Access Compliance Report Public Rights-of-Way (Curb Ramps)

Main Street: SKYLINE_DR **Cross Street:** NEWPORT_AVE **Location:** S

ADA ID: RPRK220126104846 **Ramp Type:** Type 4 - Parallel **Initial Pass/Fail:** Fail **Overall Compliance:** No **Severity Score:** 15

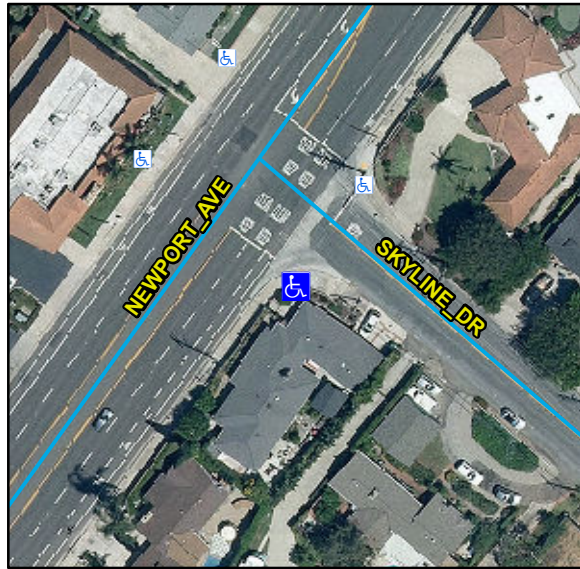
OC Std/PROW:
 R304.3.2, STD 1115

Compliance	Description	Data	Compliance	Description	Data
N/A	Ramp Length LT (in)	104	N/A	Ramp Length RT (in)	92
Yes	Ramp Width LT (in)	96	Yes	Ramp Width RT (in)	96
No	Ramp Run Slope LT (%)	9.1	Yes	Ramp Run Slope RT (%)	4.3
Yes	Ramp Cross Slope LT (%)	1.4	Yes	Ramp Cross Slope RT (%)	1.8
N/A	Landing Present	N/A	N/A	DWS Provided	N/A
N/A	Landing Length (in)	N/A	N/A	DWS Contrast	N/A
N/A	Landing Width (in)	N/A	N/A	DWS Length (in)	N/A
N/A	Landing Run Slope (%)	N/A	N/A	DWS Full Width	N/A
N/A	Landing Cross Slope (%)	N/A		DWS Offset Type	N/A
N/A	Landing Movement Obstructed?	N/A	N/A	DWS Offset Left (in)	N/A
	Landing Movement Type	N/A	N/A	DWS Offset Right (in)	N/A
N/A	Landing Shared	N/A			
N/A	Clear Space	Yes			
N/A	Clear Space To Crosswalk (in)	N/A			
N/A	Marked Crosswalk 1	No	N/A	Marked Crosswalk 2	No
	Crossing 1 Direction	NE		Crossing 2 Direction	NW
N/A	Marked Crosswalk 1 Width (in)	N/A		Marked Crosswalk 2 Width (in)	N/A

Possible Solutions:
Remove & Replace Curb Ramp With Two New Directional Ramps or Equivalent.
